CITY OF NEWTON, MASSACHUSETTS

Department of Planning and Development

SUBJECT: Petition # 211-10, PALUMBO FAMILY TRUST, for a SPECIAL PERMIT, SITE PLAN APPROVAL, REPLACEMENT OF NONCONFORMING USE WITH ANOTHER NONCONFORMING USE to demolish an existing two-family dwelling and replace it with six 2.5-story attached dwelling units, with associated waivers from the 24-foot height requirement and from parking requirements for maneuvering space/aisles/driveway width/handicap parking, and to construct a greater than four-foot retaining wall within the side setback at 244 ADAMS ST, NONANTUM, WARD 1, SECTION 14, BLOCK 14, LOTS 3 & 4, consisting of 13,966 SF of land in a BUSINESS 2 DISTRICT. Ref: 30-24, 30-23, 30-21(b), 30-19 (h)(2)(c), 30-19(h)(2)(e), 30-19(h)(3), 30-19(h)(4)(a), 30-15, 30-19(m) and 30-5(b)(4) of the City of Newton Zoning Ordinance Revised 2007.

Re: Special Permit – 244 Adams Street

Proposed Elevations

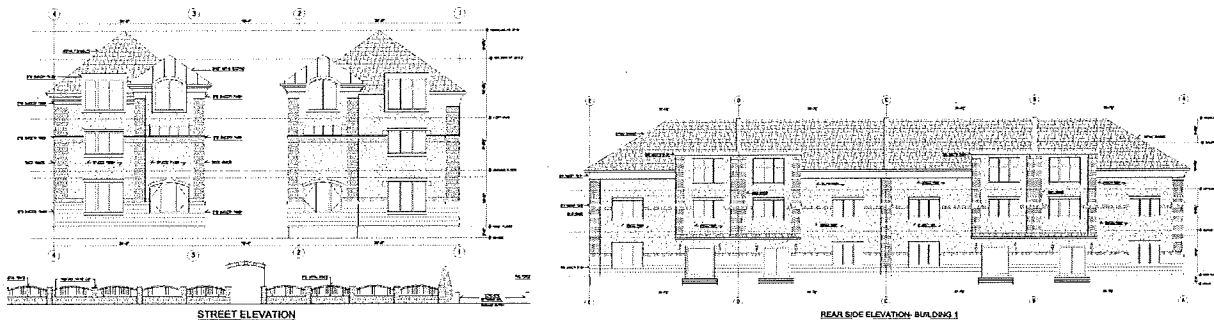
Both proposed buildings will be a combination of brick veneer and stucco finish with mix of asphalt shingles and sheet metal roofing. The variation of materials will be helpful in breaking up the mass of the buildings. The buildings will be 32.5' tall which does exceed the height of the neighboring 2- to 2.5- story buildings.

It is not indicated how refuse will be removed from the property. If a dumpster will be located on site, it should be shown on the site plan along with adequate screening.
